RE: BENNETTS GREEN BUNNINGS AND BULKY GOODS DEVELOPMENT

1. As requested, we are writing regarding matters raised by council and RMS in relation to the above development. We have previously prepared a report¹ which was submitted with the development application.
2. The council email of 27 September and RMS letters of 26 October 2017 include a number of traffic and parking matters. In response to the matters raised, amended plans have been prepared by the project architect. These matters, and our responses, are set out below.

**19.0m ARTICULATED
 VEHICLE SWEEP PATHS**

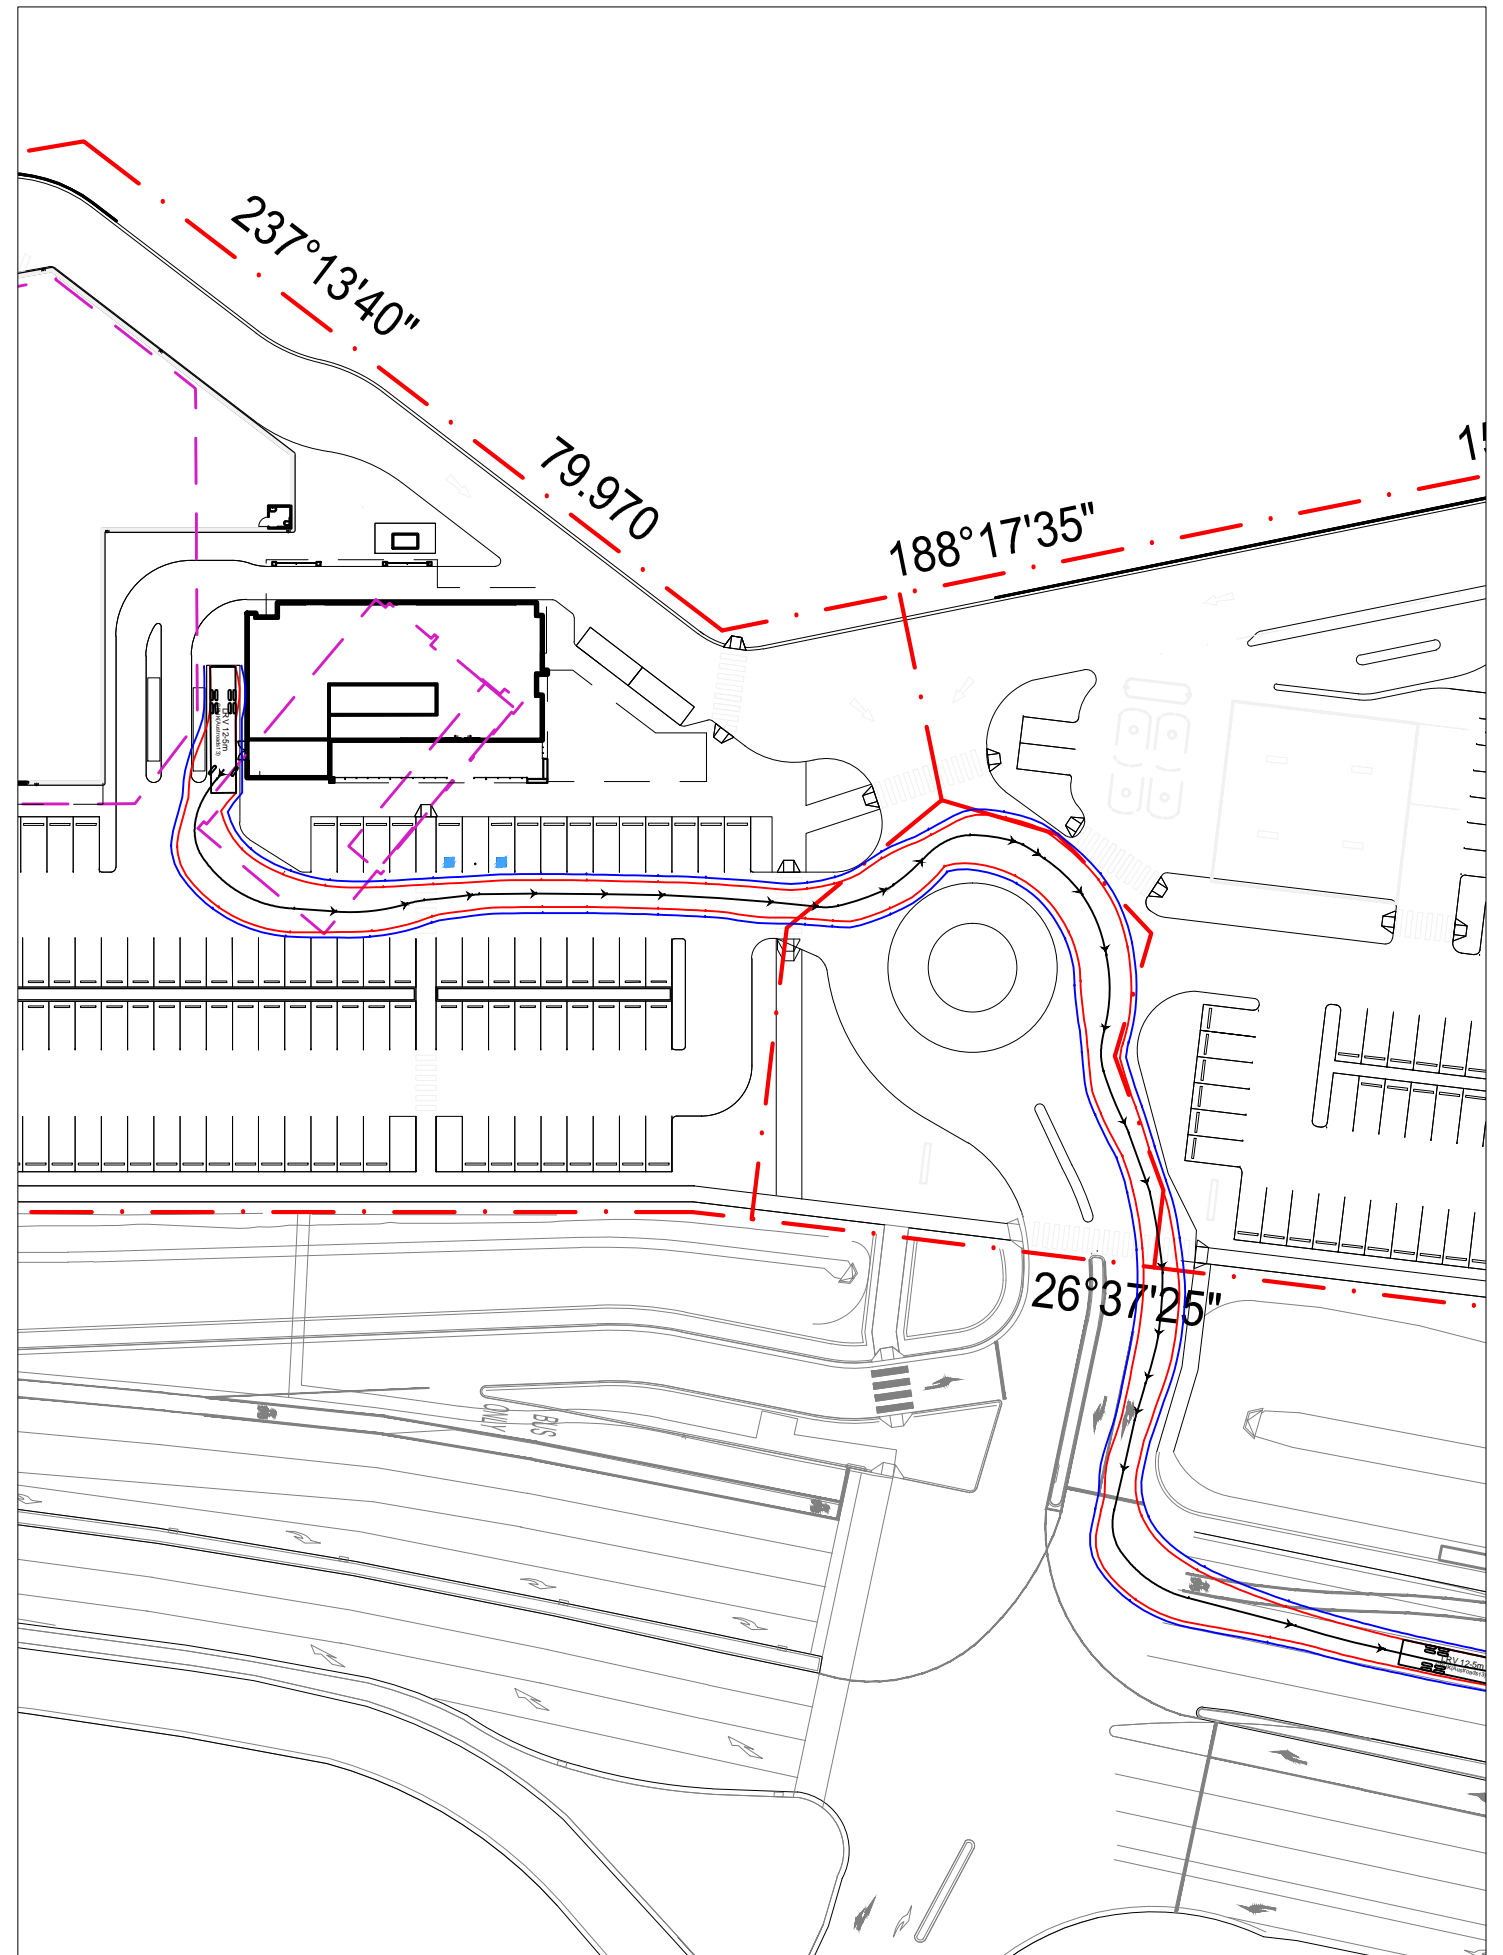
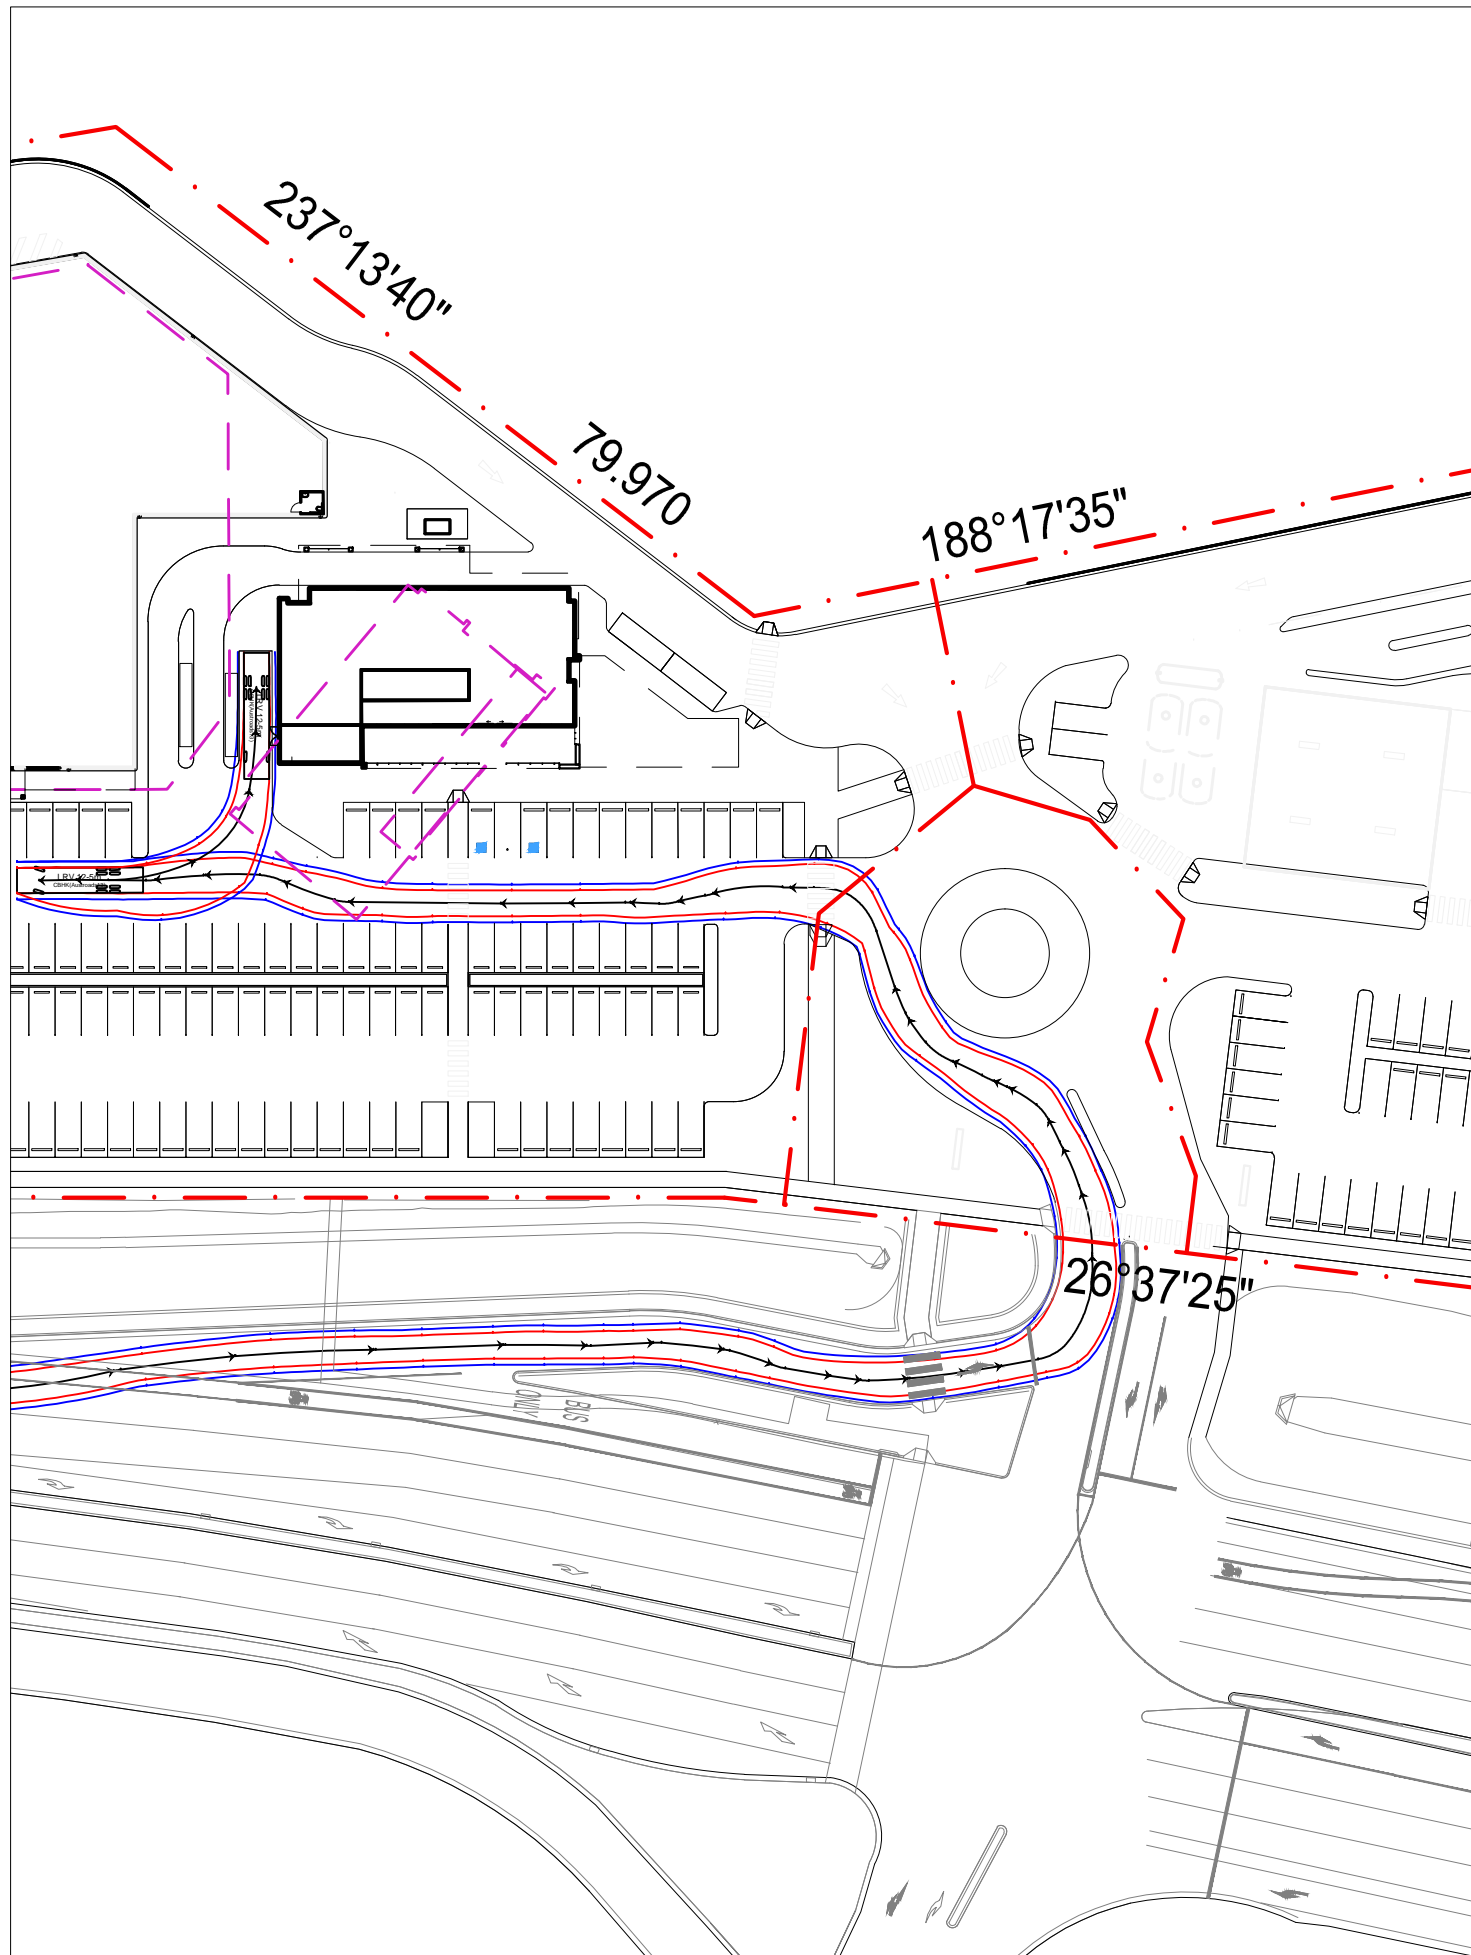
6. The proposed arrangements are therefore considered to be appropriate.
 - *Building Products Warehouse and Showroom*
 - 1) *The access ramp/driveway from South Street to the rear service bay of the Building Products Warehouse and Showroom requires additional detail in the form of widths, clearances and the like, inclusive of swept paths from South Street, through the access ramp and within the service delivery bay...*

- *Servicing*
 - 1) *Details of service vehicles including swept paths are required for internal areas (deliveries and waste collection) for the Building Products Warehouse & Showroom as well as the Bulky Goods Units and Restaurant. Additionally movements at the (Bunnings service vehicles) South Street and the Pacific Highway access points are to be provided.*

- *Details for servicing (deliveries & waste collection) the development are required in terms of manoeuvring/swept paths.*

7. Vehicle swept paths are attached to this letter as Figures 1 to 12.
 - *Parking*
 - 1) *The development provides a total 846 car parking spaces, 13 additional non-discriminatory parking spaces and 2 waiting bays. An assessment based on the proposed GFA identified 697 car parking spaces and 14 non-discriminatory parking spaces as being required. Therefore as an excess in car parking is proposed a reduction is required as per Council's DCP and to improve landscaped outcomes.*

21. Service vehicle swept paths are shown in Figures 1 to 12.

- *The plans are ambiguous as to how vehicles will access the Take Away Food & Drink Premises. It appears vehicles are required to access the drive thru via the entrance of the Service Station, which could become quite congested considering queuing for petrol bowsers. Details are required on how vehicles will access the drive thru and what will prohibit these vehicles travelling on the Service Road in the opposite direction to Service Vehicles.*

16. Vehicles will enter this drive-through from the service station, in a similar manner to many other service station/fast food developments. The swept paths attached in Figure 12 show that with two vehicles queued at the petrol bowers, other vehicles will be able to readily circulate to the drive-through.
17. There will be appropriate no entry signage at the western leg of the roundabout, which will apply to service vehicles and general traffic.
